YANKEE ATOMIC ELECTRIC COMPANY

November 7, 1975

- Reference:
- (1) License No. DPR-3 (Docket No. 50-29)
 - (2) Proposed Change No. 125 (July 14, 1975).
 - (3) Proposed Change No. 125, Supplement No. 1 (October 10, 1975).
 - (4) Proposed Change No. 125, Supplement No. 2 (October 28, 1975).
 - (5) Letter from R. A. Purple to R. H. Groce, dated October 30, 1975 regarding questions on Proposed Change No. 125.

Subject: Core XII Analysis

FIGURE 1

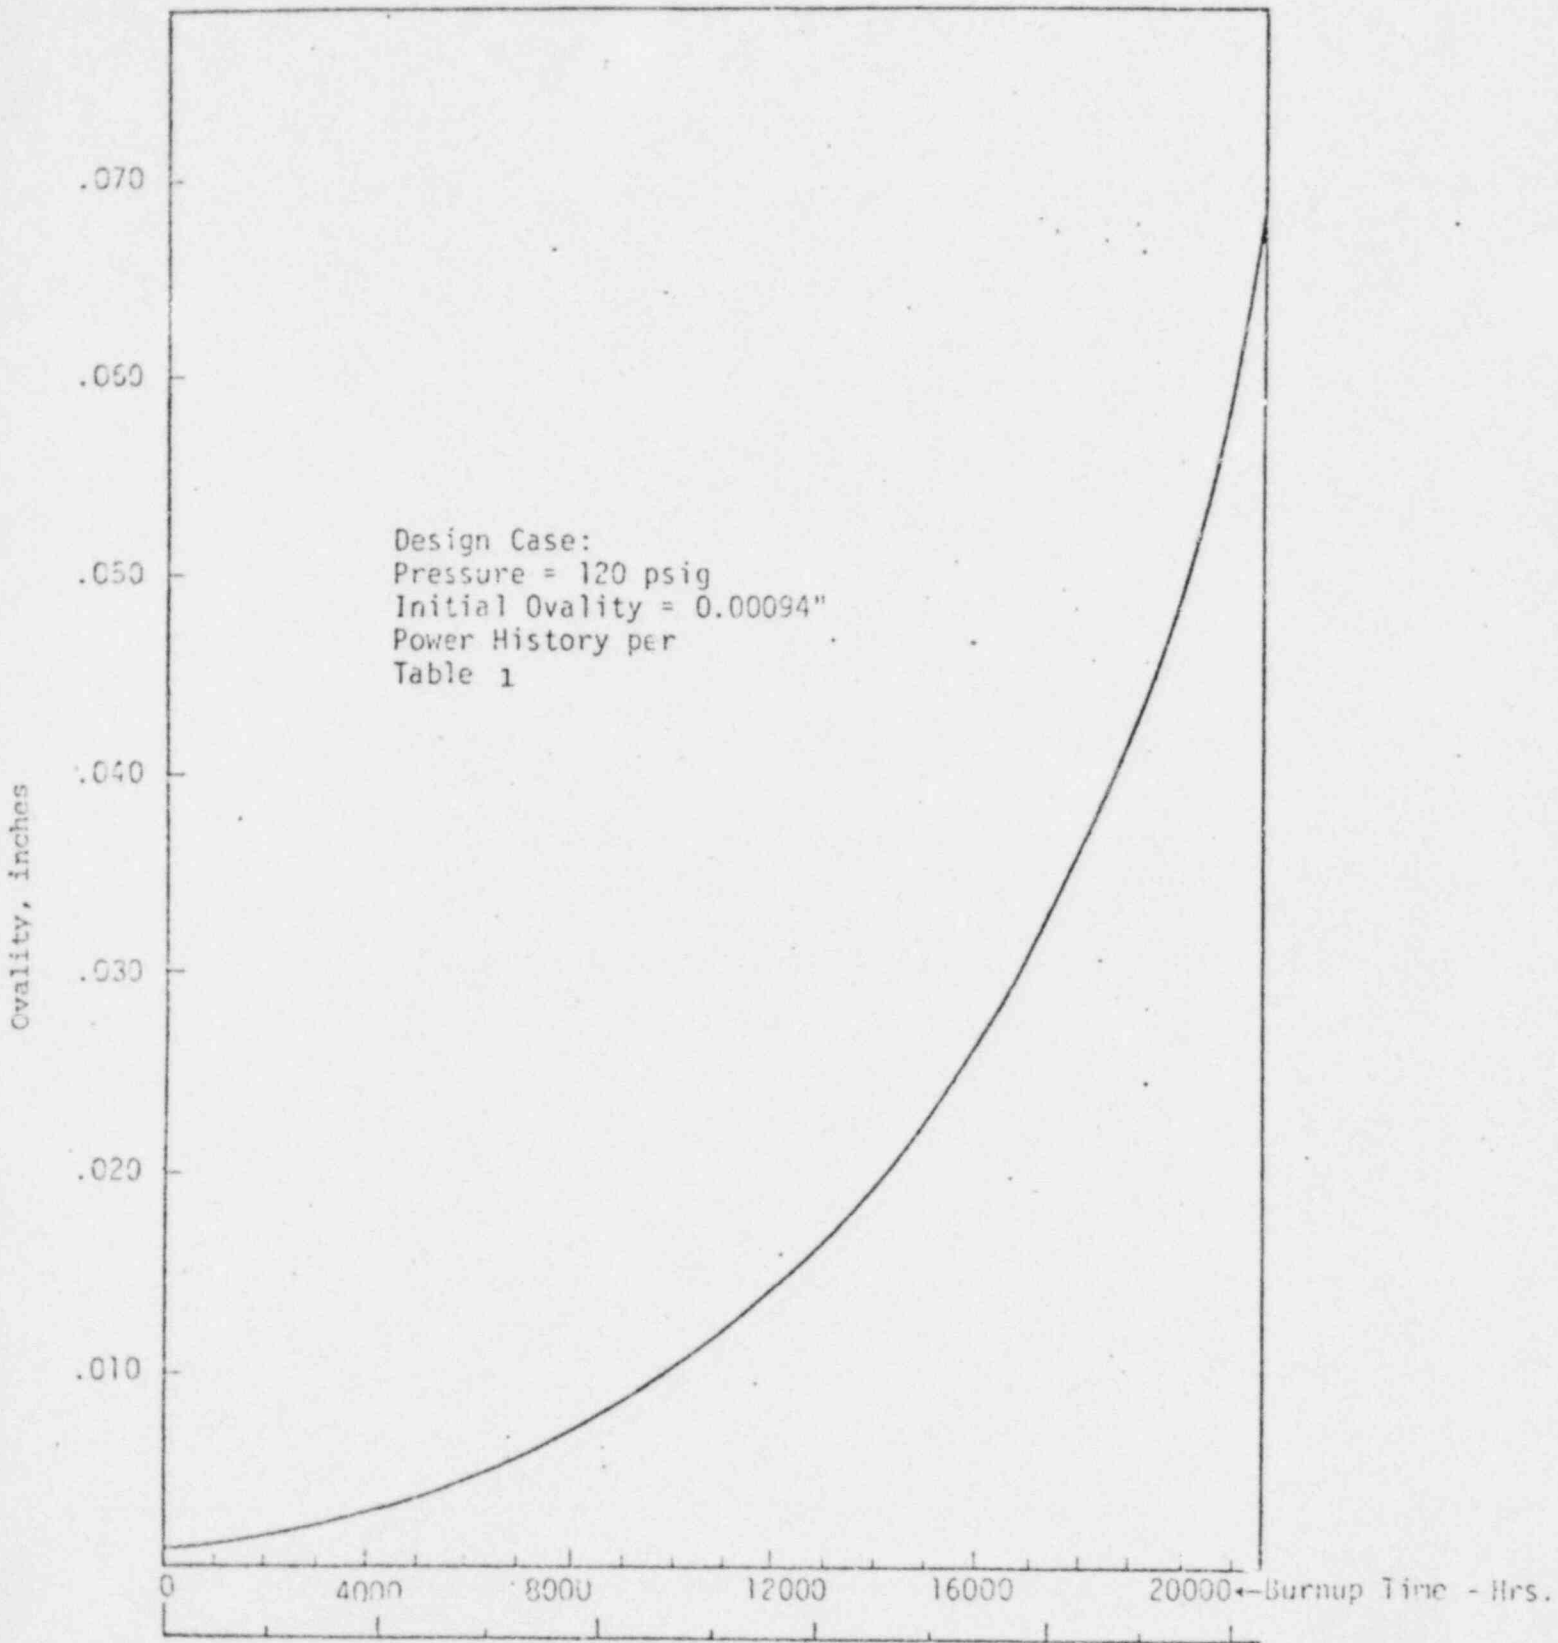
Provide input values and results for the cladding creep collapse calculation.

Listed below are the input values used in the creep collapse calculations for the Yankee Rowe Fuel:

Results of the creep collapse calculations are summarized in Figure 1 which shows ovality as a function of time. Ovality at the end-of-life (21000 hours) is calculated to be approximately .060 inches. Clad collapse is not predicted for the residency time of the fuel in the core.
